PUBLIC HEARING MEMORANDUM

SUBJECT: **Petition #30-21**, petition for a SPECIAL PERMIT/SITE PLAN APPROVAL to amend Special Permit Board Orders #94-16 and #227-17 to substitute the previously approved site plan with an as-built site plan reflecting additional features which include changes to paving, landscaping, the addition of a paved patio area and additional stone pillars at 2171 Commonwealth Avenue, Ward 4, Auburndale, on land known as Section 41 Block 18 Lot 32A, containing approximately 20,952 sq. ft. of land in a district zoned SINGLE RESIDENCE 3. Ref: Sec. 7.3.3, 7.4 of Chapter 30 of the City of Newton Rev Zoning Ord, 2017.

MEMORANDUM

Re: Special Permit – 2171 Commonwealth Avenue

Approved Building Permit Plan Dated: October 4, 2016

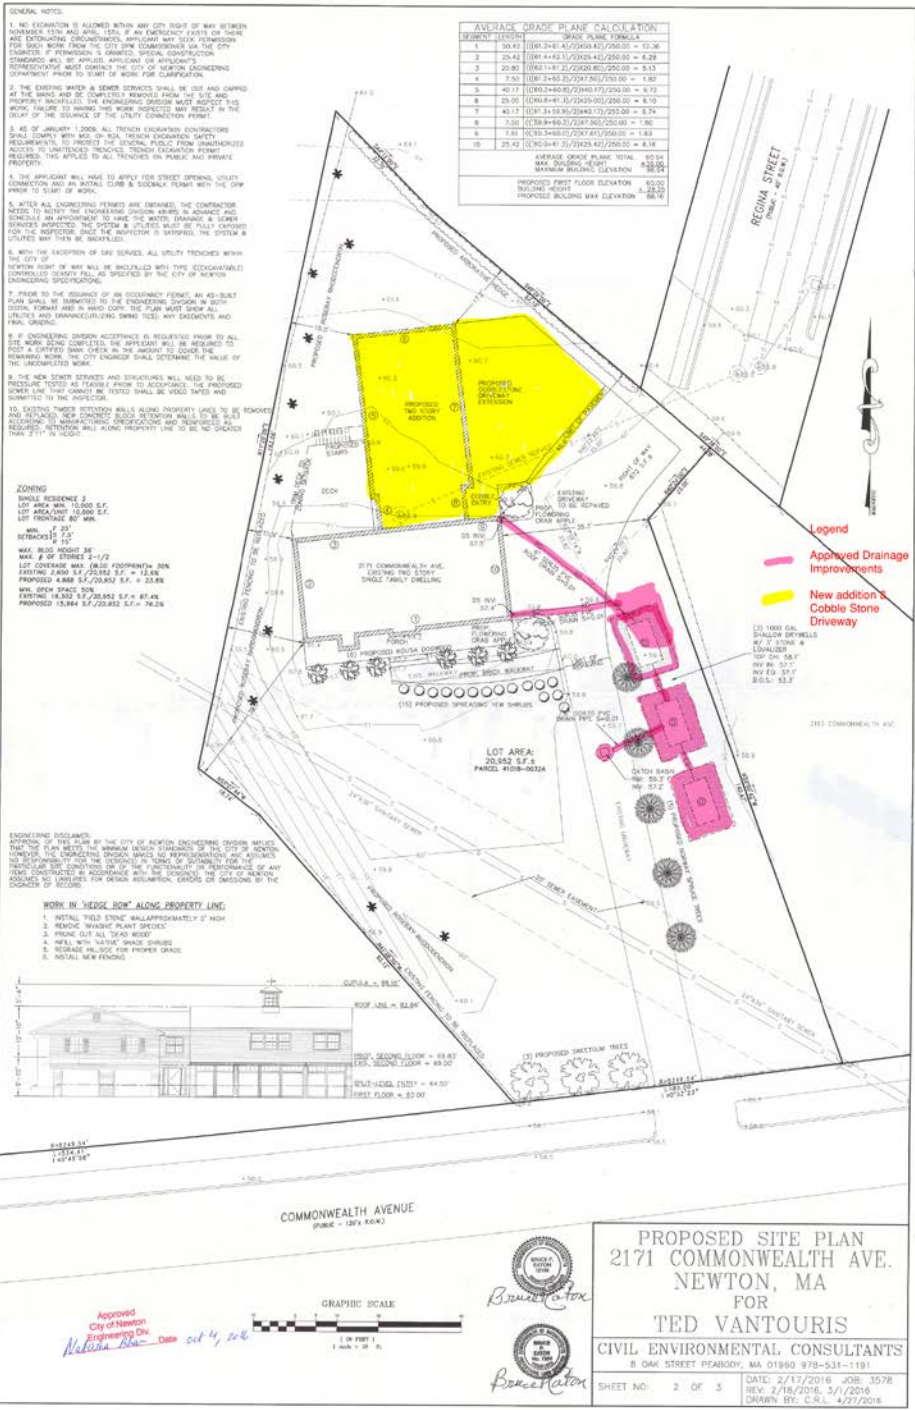
This site received a Building Permit approval on October 16, 2016 for an addition and expanded driveway, the proposed drainage improvements were designed to collect runoff from the addition, the existing and expanded driveway, see attached plan.

As Built Plan Dated: 4-24-'19

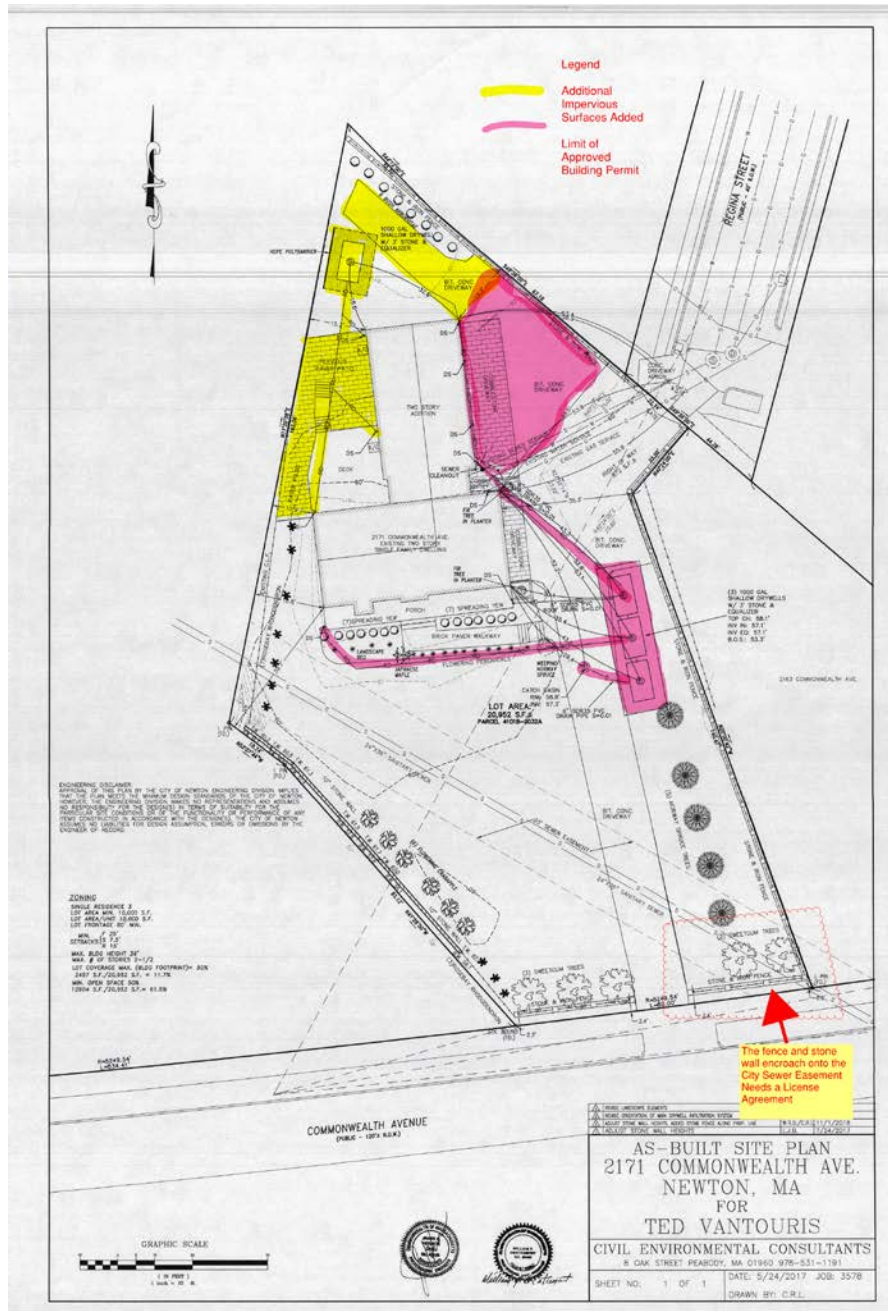
The As built plan shows that the applicant expanded the driveway beyond what was approved on the original Building Permit. This plan has an extend hammerhead turnaround added (highlighted in yellow are: approximately 625 square feet and pervious patio area approximately 567 square feet) toward the west property line. The as built plan also shows additional dry well system added to receive runoff from the new addition and the existing home, however not from the hammerhead, (see plan below).

Additionally, a stone wall and iron fence have been installed along the frontage and specifically on top of the City Sanitary sewer main easement, this will require a License Agreement.

Based on a site visit yesterday and observing the expanded hammerhead area (from outside the fence), it appears that any runoff from this area will remain on site sheet off towards the existing lawn and not impact the neighboring property at # 23 Regina Road which is at a higher elevation than this property.
